Project	IEEE 802.16 Broadband Wireless Access Working Group < http://ieee802.org/16 >	
Title	MR_Traffic-REP message	
Date Submitted	2007-11-14	
Source(s)	Kanchei (Ken) Loa, Yi-Hsueh Tsai, Yung-Ting Lee, Hua-Chiang Yin, Shiann-Tsong Sheu, Youn-Tai Lee	Voice: +886-2-27399616 Fax: +886-2-23782328 loa@iii.org.tw
	Institute for Information Industry 8F, No. 218, Sec. 2, Dunhua S. Rd., Taipei City 106, Taiwan	
	[add other co-authors here]	
Re:	IEEE 802.16j-07/043: "IEEE 802.16 Working Group Working Group Letter Ballot #28"	
Abstract	This contribution proposes MS ranging and automatic adjustments in transparent and non-transparent	
Purpose	Text proposal for 802.16j Draft Document.	
Notice	<i>This document does not represent the agreed views of the IEEE 802.16 Working Group or any of its subgroups. It represents only the views of the participants listed in the "Source(s)" field above. It is offered as a basis for discussion. It is not binding on the contributor(s), who reserve(s) the right to add, amend or withdraw material contained herein.</i>

MR_Traffic-REP message

In order to facilitate the incorporation of this proposal into IEEE 802.16j standard, specific changes to the draft standa

Figure 118b—SS upstream transmission adjustment at a transparent RS performing uplink relay only

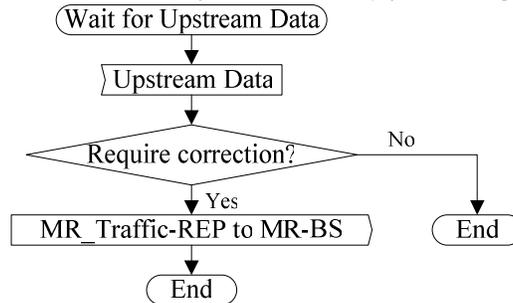
[Replace Figure 118b in comment #0565 (C802.16j-07/459r6) by following figure as indicated:]
